DUKE POWER COMPANY
OCONEE NUCLEAR STATION

Attachment 2
Basis for Emergency Situation
Post Maintenance/Modification
Leak Rate Testing

Technical Justification

Post Maintenance/Modification

FIGURE 1

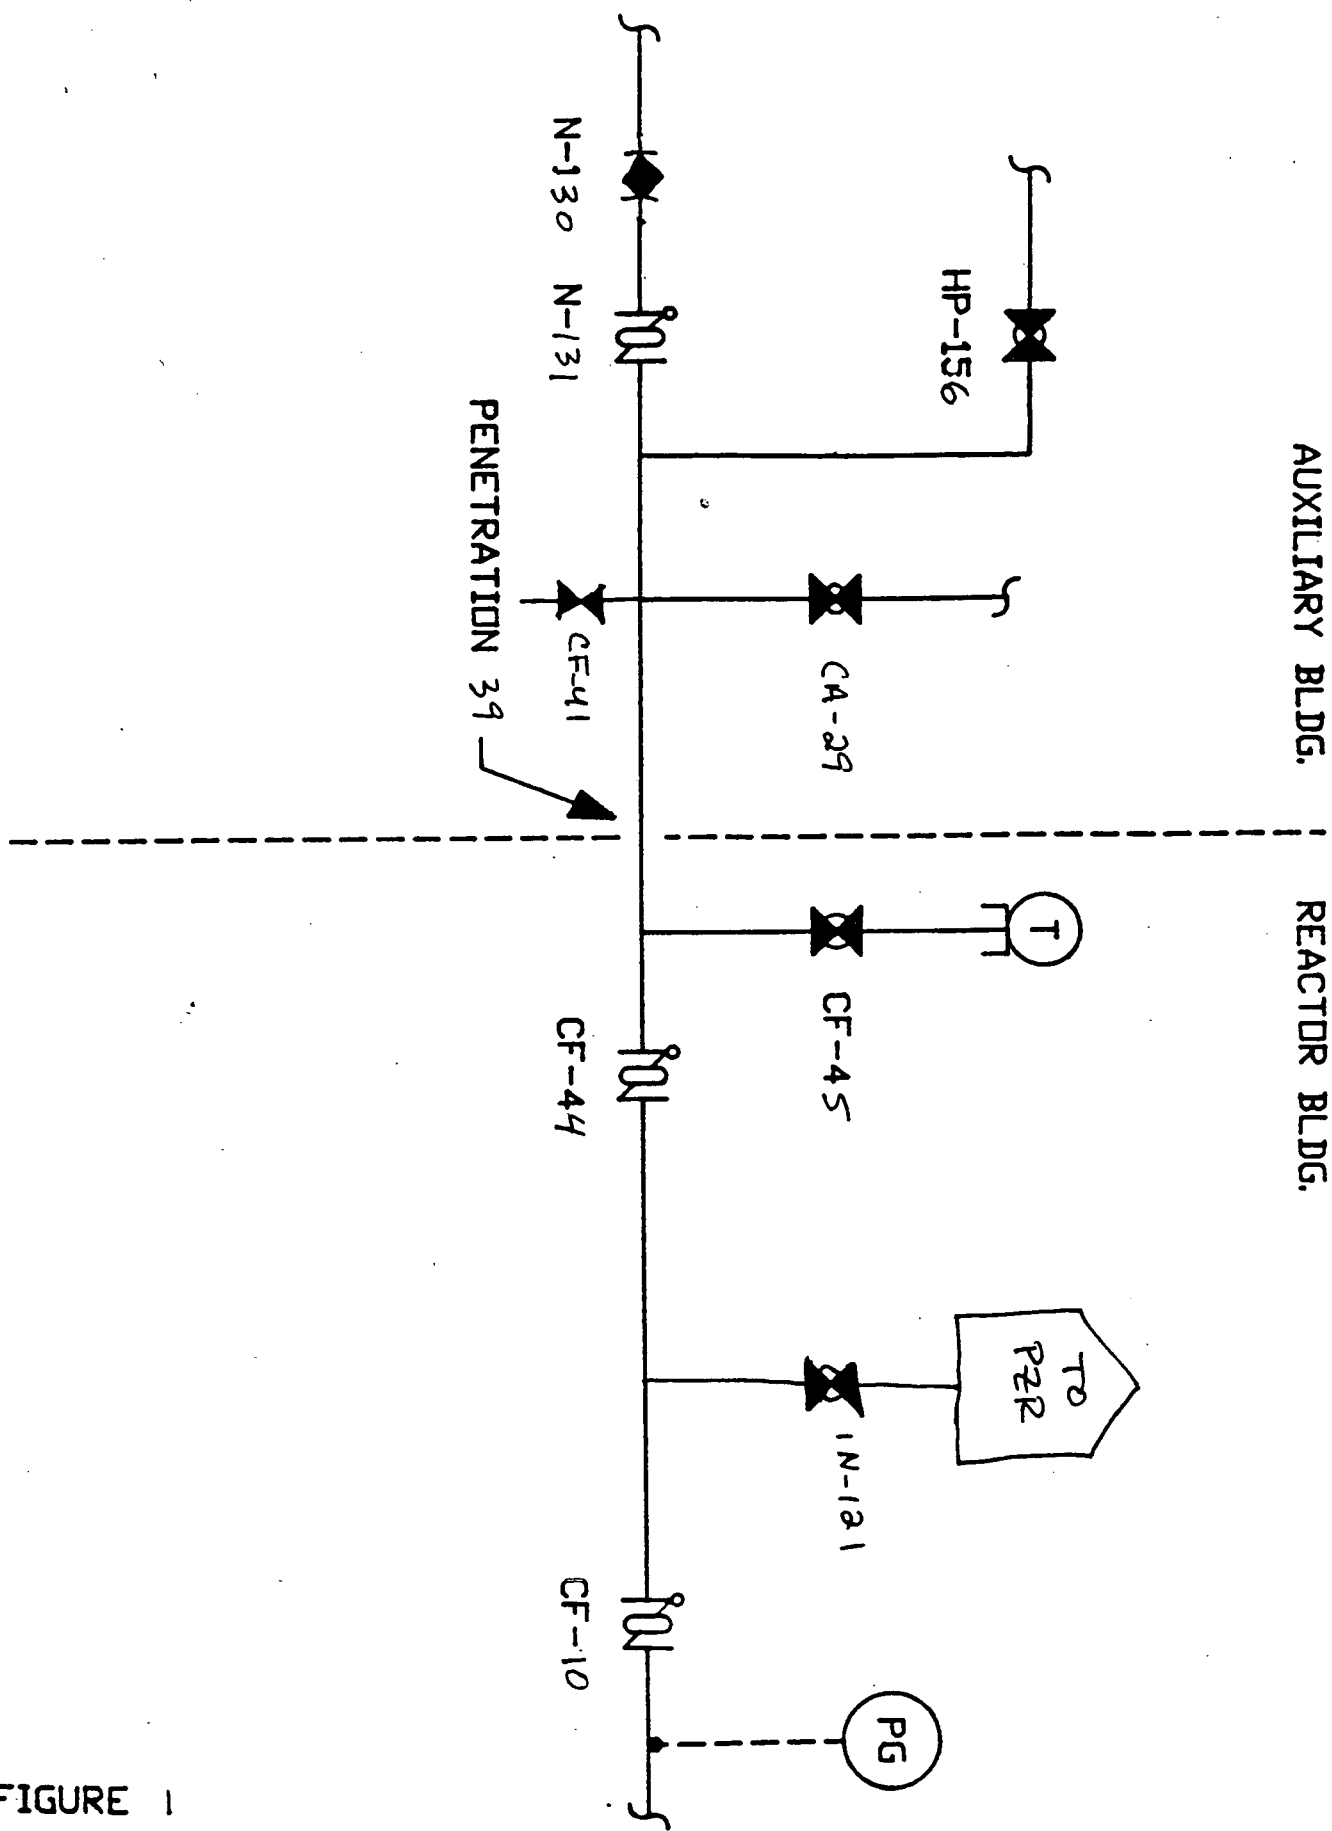
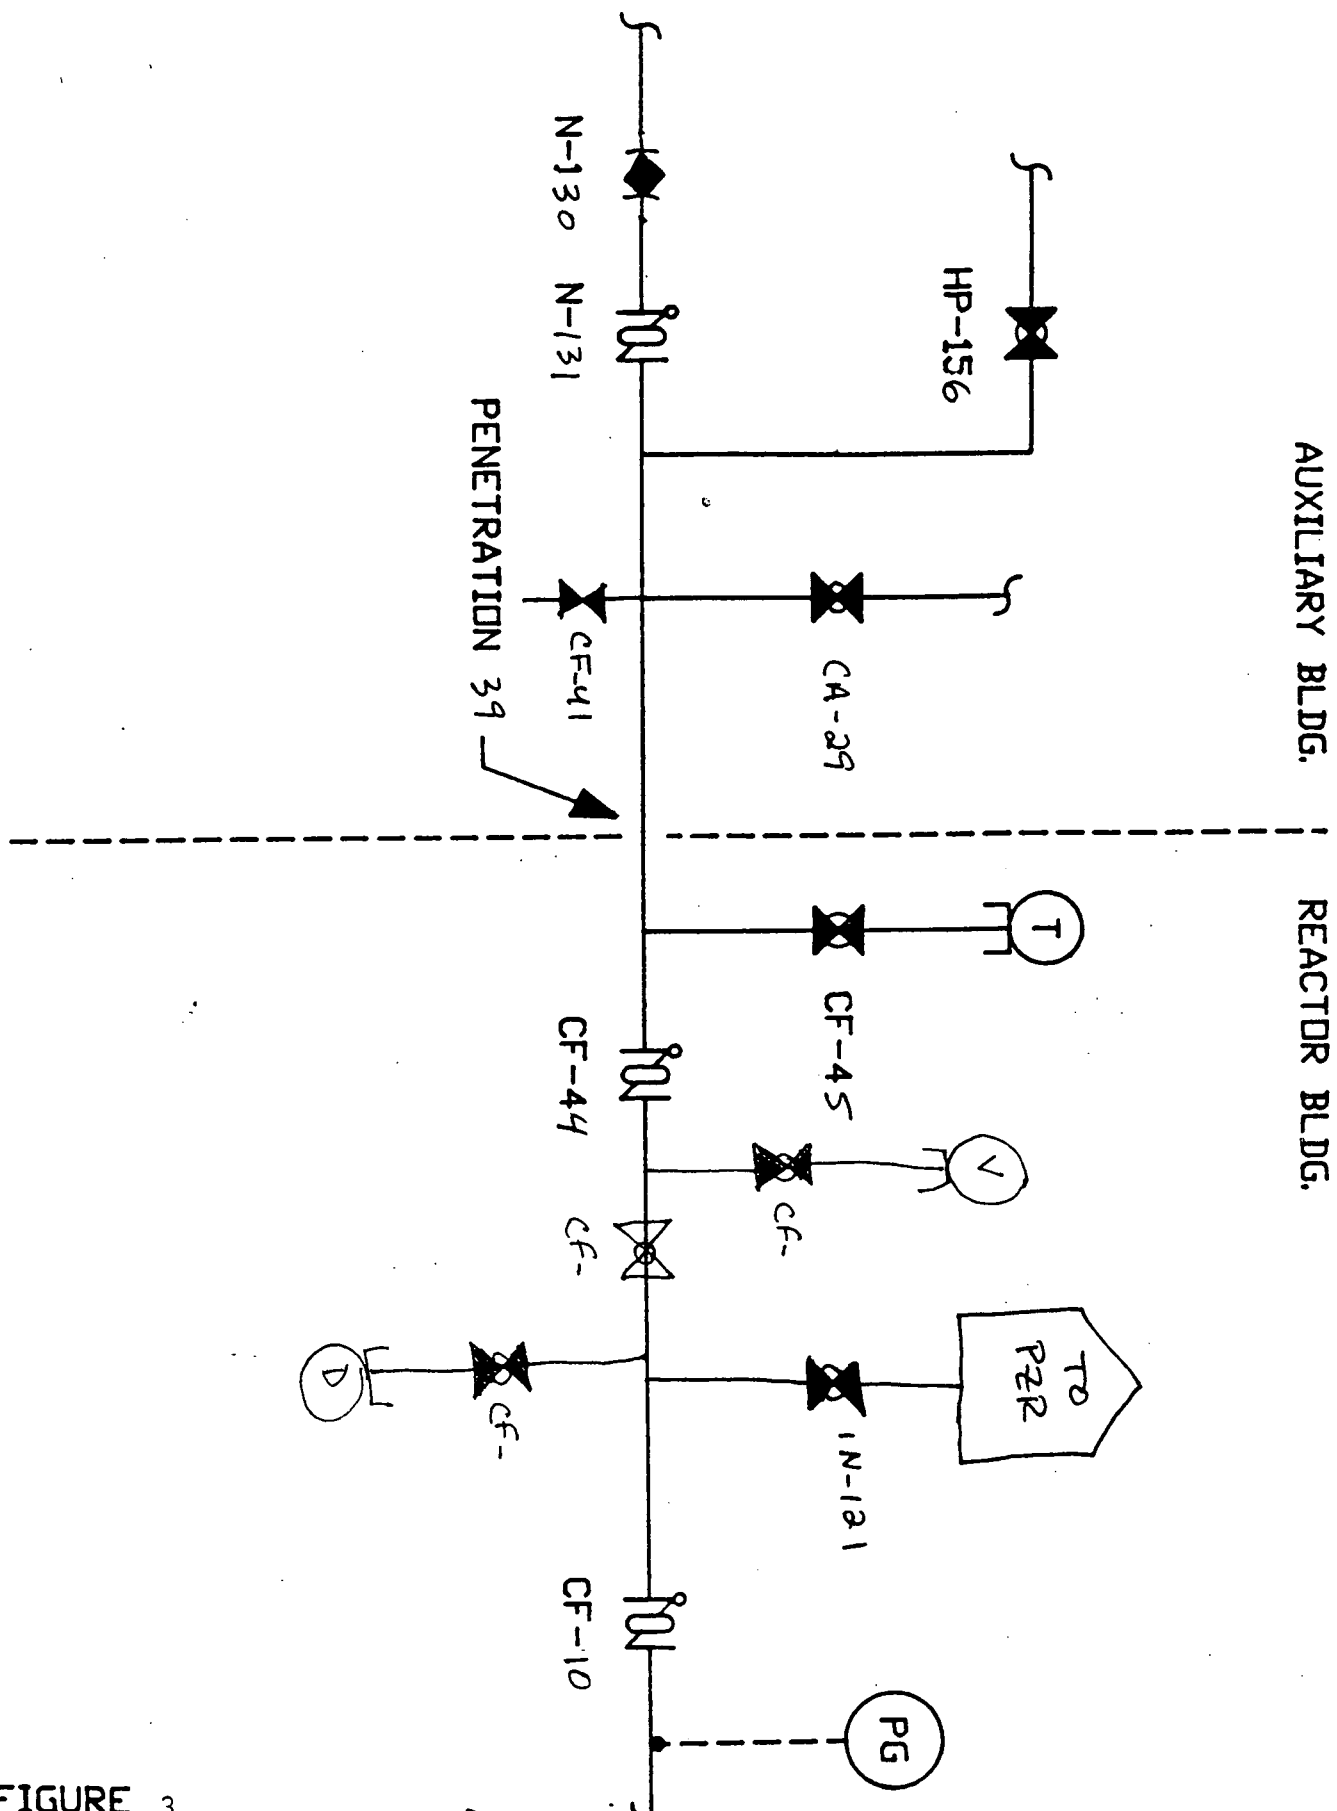
Figure 1 illustrates the current configuration of penetration 39. The following table identifies valves within penetration 39 on which maintenance was performed or modifications were implemented, but which were not leak rate tested prior to establishing containment integrity.

Unit 1	1N-131 1CA-29
Unit 2	2CF-44
Unit 3	3N-131

Figures 1 and 2 provide the current configuration of penetrations 39 and 53 respectively. Existing approved Technical Specifications do not require Type C testing for these penetrations, thus none was performed. During previous Type A tests, penetration 39 was challenged as required. As discussed in the September 29, 1989 amendment request, penetration 53 was not challenged by the Type A test as required. Further, certain valves within penetrations 39 and 53 were not tested as required following maintenance or modification. As a result, a conservative determination has been made by Duke Power Company that penetrations 39 and 53 are technically inoperable pursuant to Technical Specification 3.6.3.

Note, all lines from the auxiliary building to penetrations 39 and 53 are double-isolated. Specifically, for penetration 39 all lines leading from the auxiliary building to valves CA-29 and HP-156 are maintained normally isolated via closed manual valves. The vent line to CF-41 is maintained normally isolated through either a closed manual valve or installation of a pressure gage at the end of the line.

To resolve the above concern, the configuration for penetrations 39 and 53 is being modified (figures 3 and 4). The modification will add a vent valve, a drain valve and a test isolation valve to the Nitrogen line that feeds the core flood tanks. The modification will allow Type C testing of CF-44 and simplify Type A testing of penetration 39. The modification will allow local leak testing of CF-42 and simplify Type A testing of

The modification effects the non-seismic portion of the Nitrogen System. The piping is non-QA and non-safety related. The new vent and drain lines and the new valves are designed for the connecting piping's design temperature and pressure. The vent and drain line will have pipe caps installed. The new valve installed in the main nitrogen line will be kept normally open. The stress analysis for the piping changes were reviewed and determined to require no support changes. These changes will not affect the safety related portion of the Nitrogen system. Technical Specification 3.3 requires the core flood tanks to have a pressure of 600 + 25 psig. This modification will not adversely affect this pressure requirement.

Until a Type C test has been successfully performed for Unit 2 and 3, the following manual valves will be maintained closed when containment integrity is required:

Penetration 39

- 1) CF-41
- 2) HP-156
- 3) N-130
- 4) CA-29

FIGURE 2

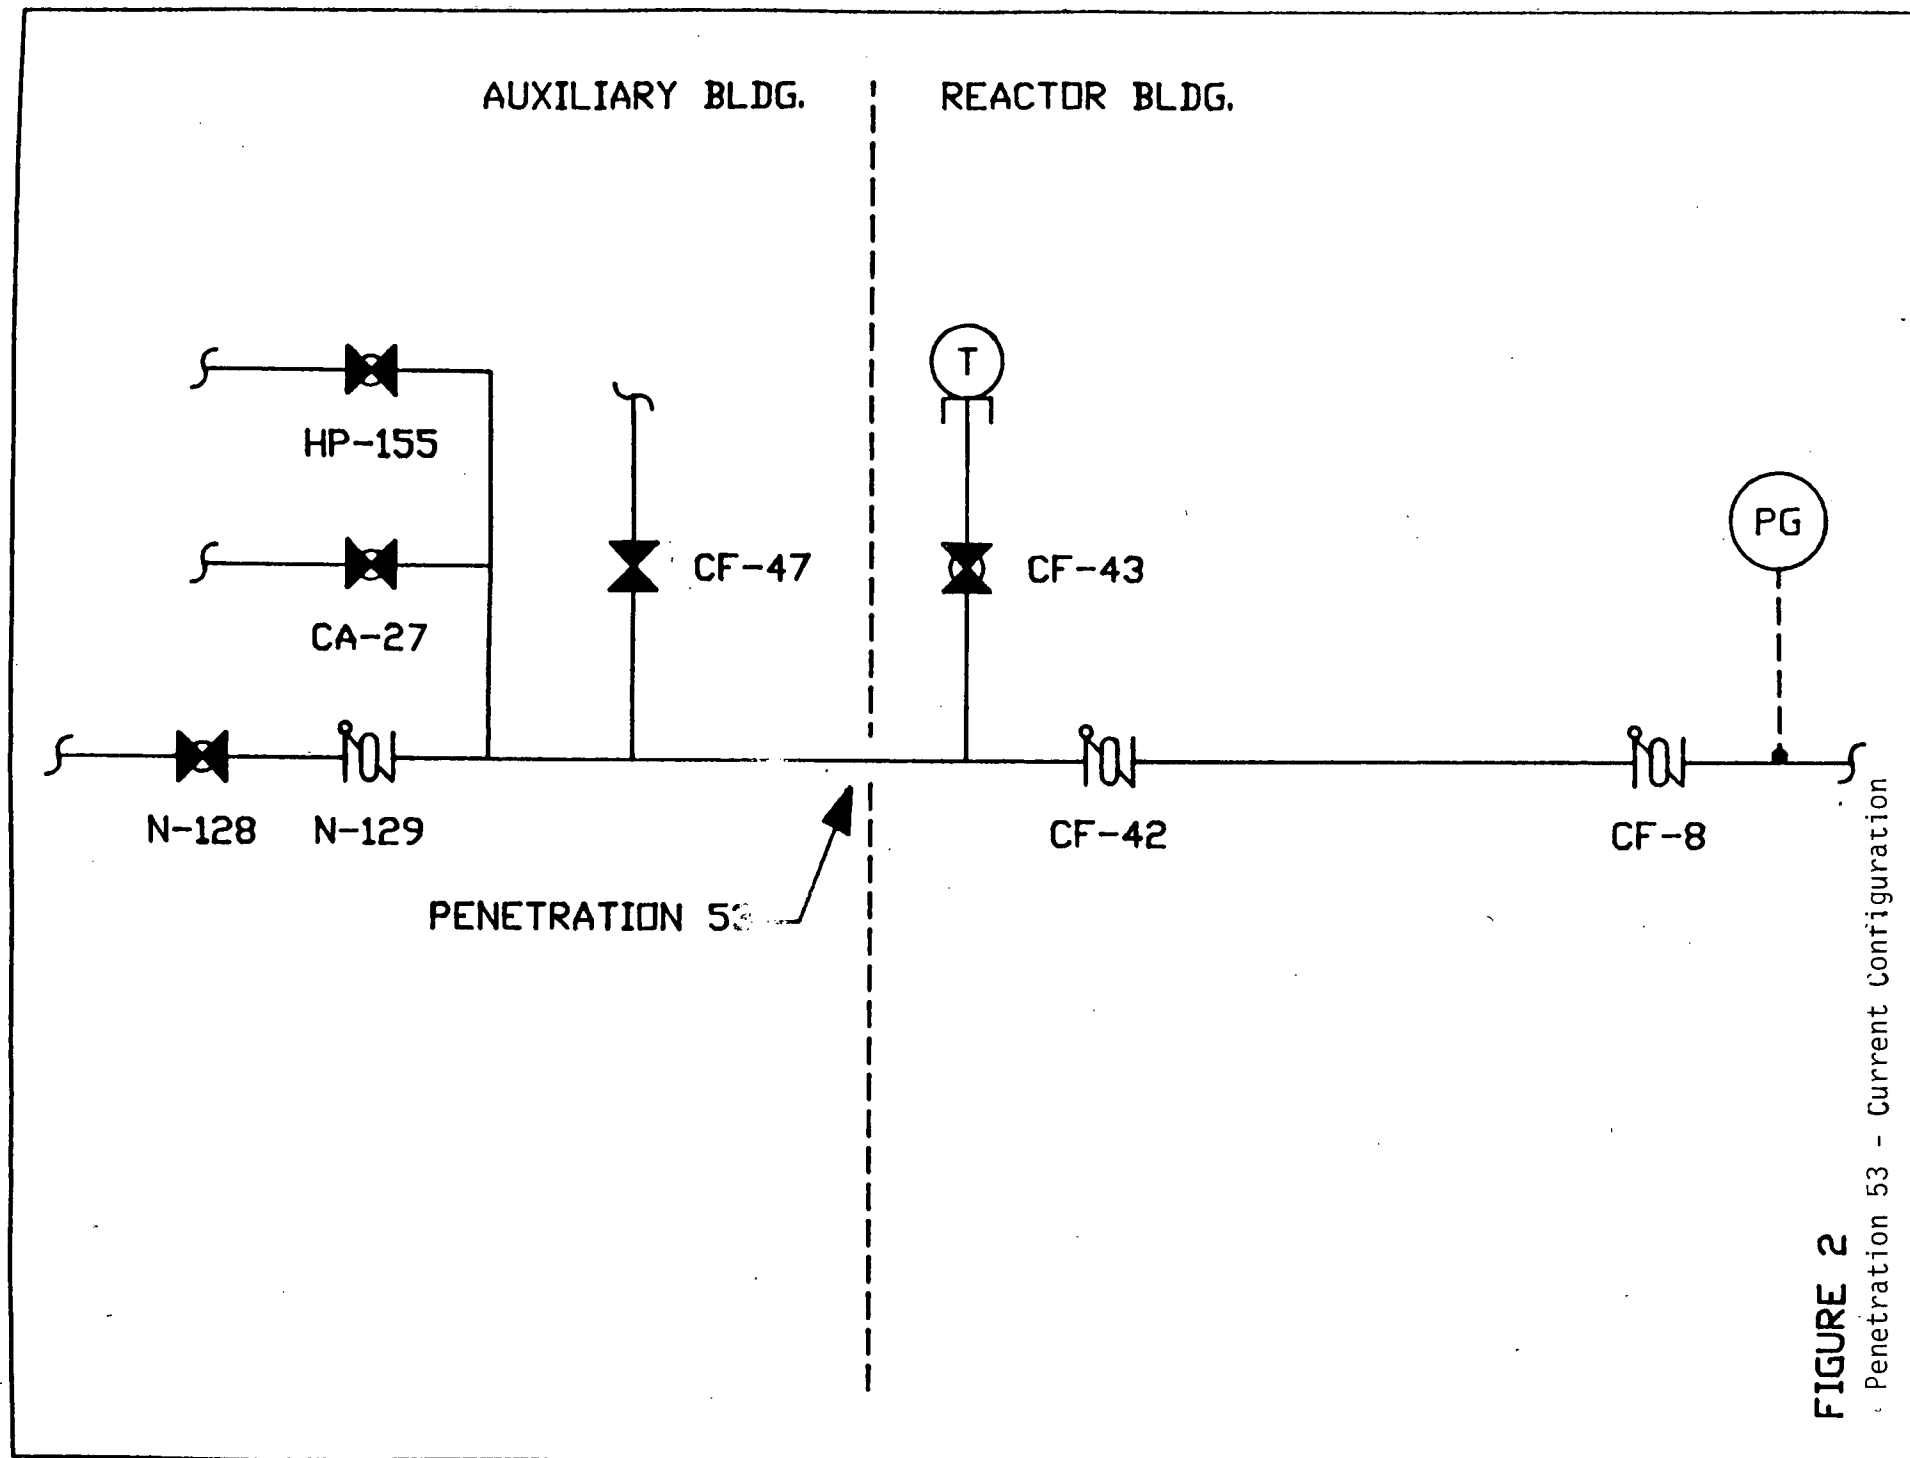
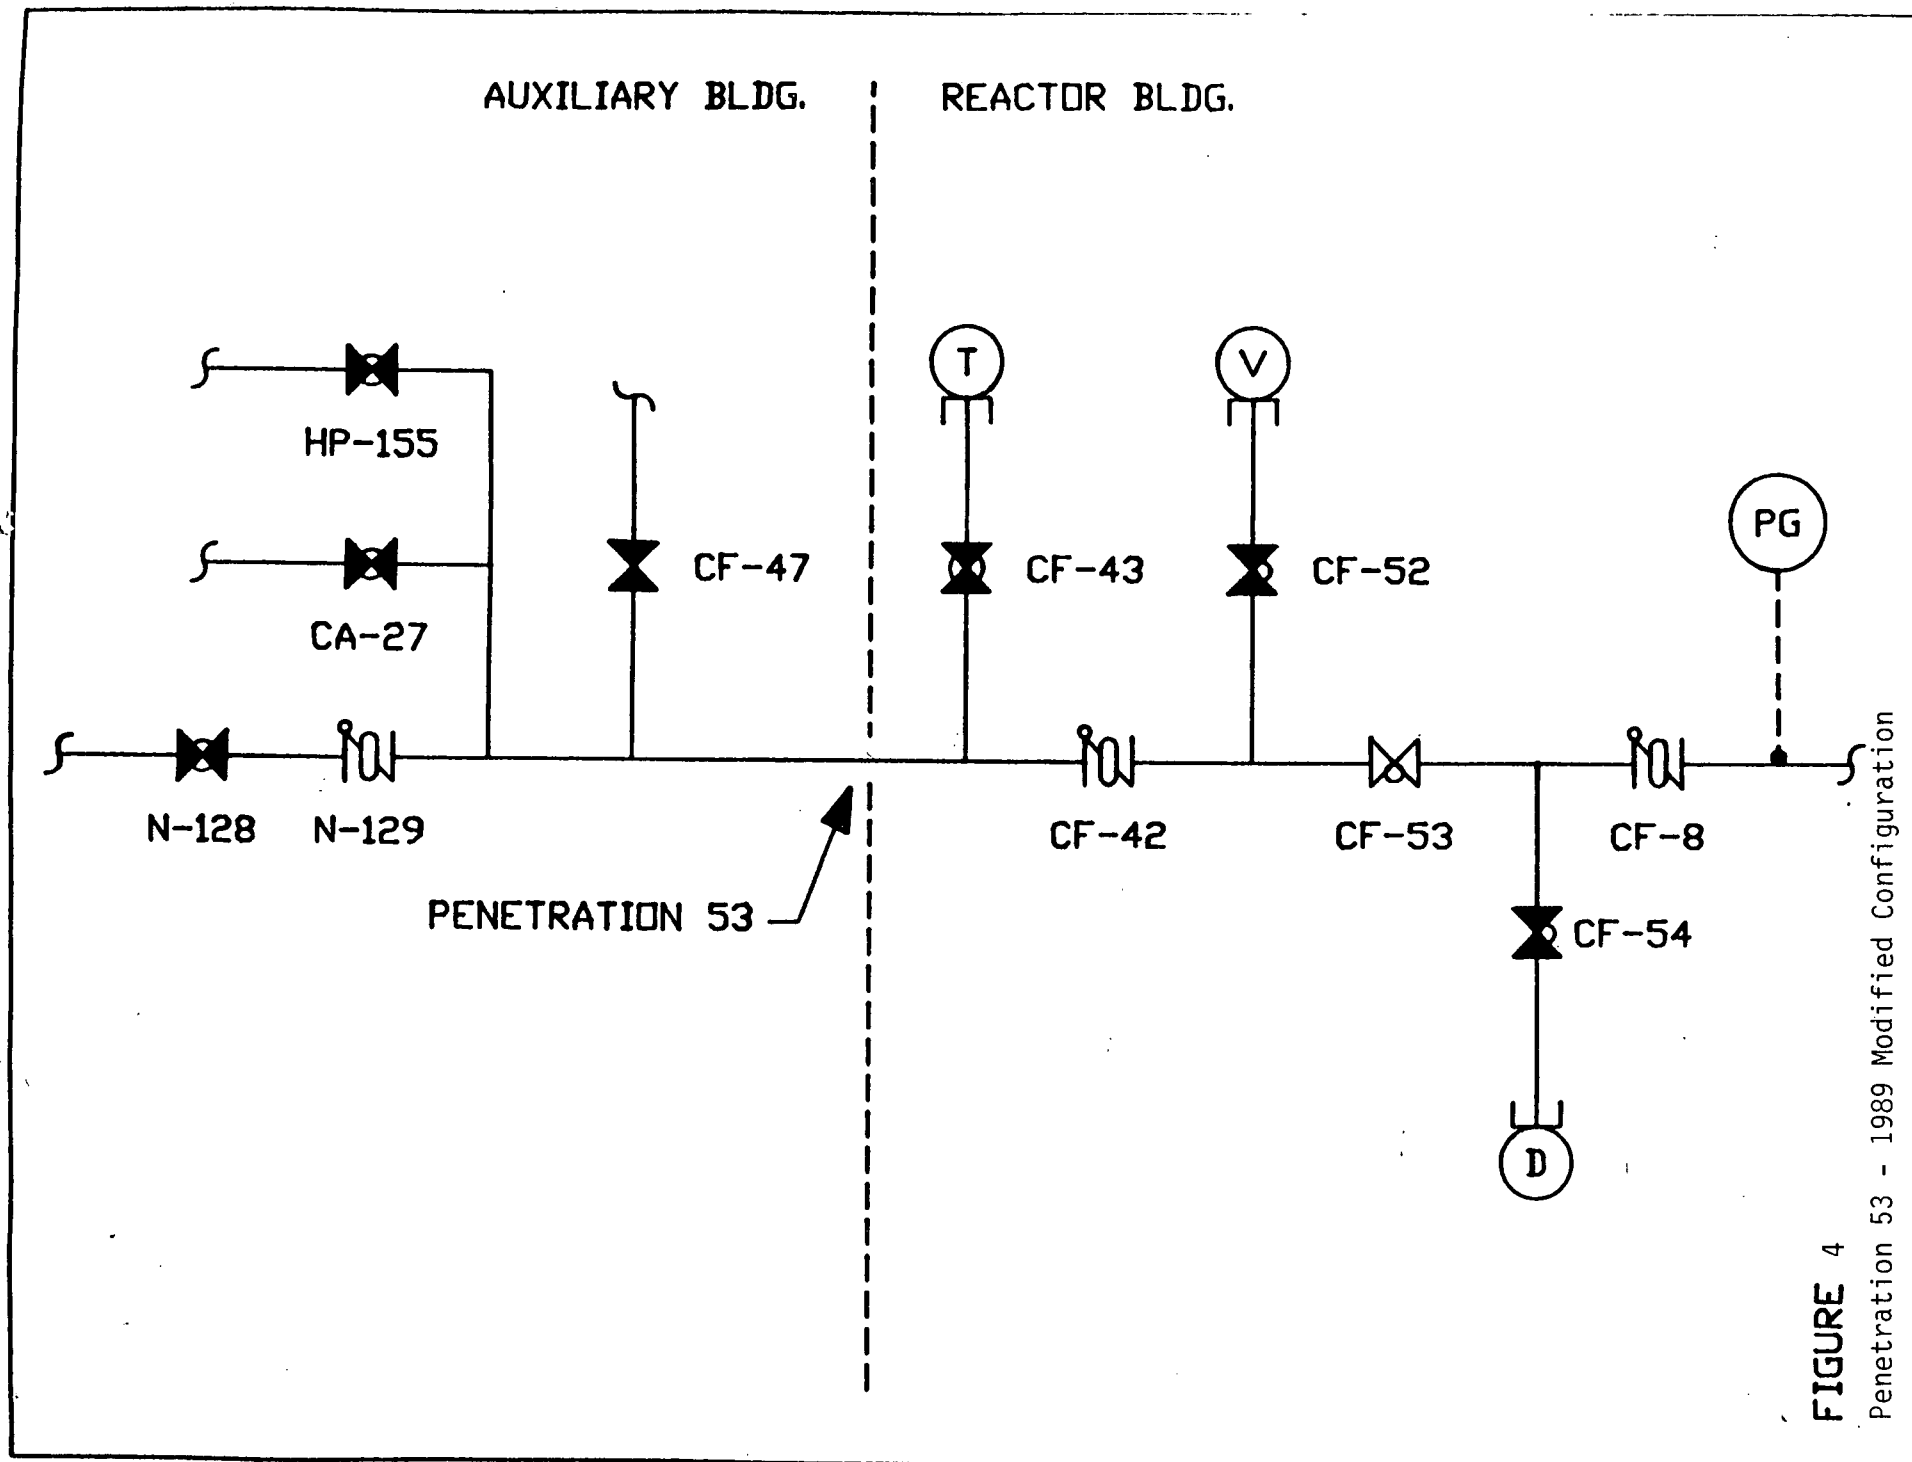
Figure 2 illustrates the current configuration of penetration 53. Post maintenance or modification leak rate testing has not been performed on the following penetration 53 valves:

Unit 1	None
Unit 2	2CF-42
Unit 3	3CF-42

For penetration 53, all lines leading from the auxiliary building to valves HP-155 and CA-27 are maintained normally isolated through closed manual valves. the vent line to CF-47 is maintained normally isolated through either a closed manual valve or installation of a pressure gage at the end of the vent line.

penetration 53. During future ILRT, the new vent line will be open to the containment atmosphere.

Penetration 53

- 1) N-128
- 2) CA-27
- 3) HP-155
- 4) CF-47
